Access Compliance Report Public Rights-of-Way (Pedestrian Signals)

Main Street: ANTONIO_PKWY Cross Street: ANTONIO_PKWY Location: SE

ADA ID: SGRK211116125330 Signal Type: One Push Button-Non APS Overall Compliance: No Severity Scores: BTN 1: 10 BTN 2: N/A No BTN: N/A

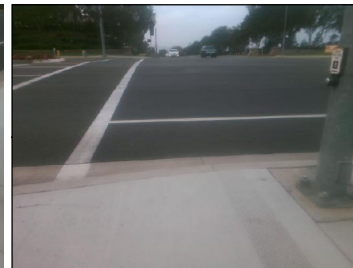
OC Std/PROW: MUTCD 4e.08

Possible Solutions: Replace Signal Push Button With APS Button. Remove & Relocate Sign.
